Communication concerning the approval and notification of approval number

of a type of pneumatic tyre for agricultural vehicles pursuant to Regulation No. 106

Approval No.: **106R-000240**

1. Manufacturer's name or trade mark (s) of the tyre: **PETLAS TA60**
2. Tyre type designation by the manufacturer: **12.4-28 8PR**
3. Manufacturer's name and address:
**PETLAS RUBBER INDUSTRY
AND TRADE COMPANY
Göhlisar Mevkii
40200 Kirsehir
TURKEY**
4. If applicable, name and address of manufacturer's representative: **N/A**
5. Summarized description:
 - 5.1. Size of tyre: **12.4-28**
 - 5.2. Category of use: **Tractor - Drive wheel - standard tread**
 - 5.3. Structure: **diagonal (bias-ply)/bias belted/radial** ^{1/}
 - 5.4. Speed category symbol: **A6**
 - 5.5. Load-capacity index: **122**
 - 5.5.1. for traction (implement only): **-**
 - 5.5.2. for trailer (implement only): **-**

DRAWING OF THE TYRE SIDEWALL **REGULATION Nr.106**

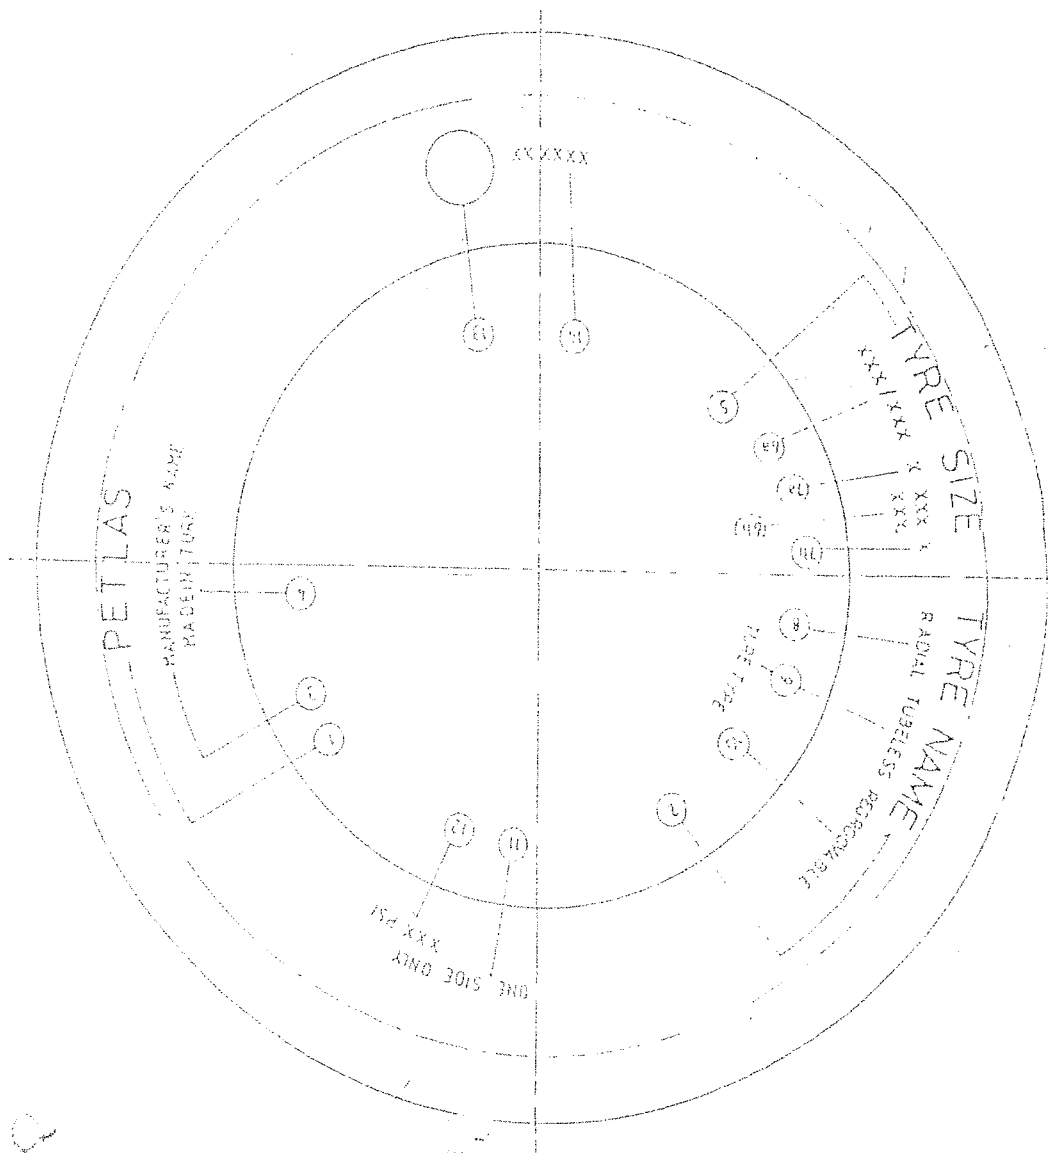
Comments	Load index and maximum inflation pressure pictogram are missing. An adjustment is necessary.
-----------------	---
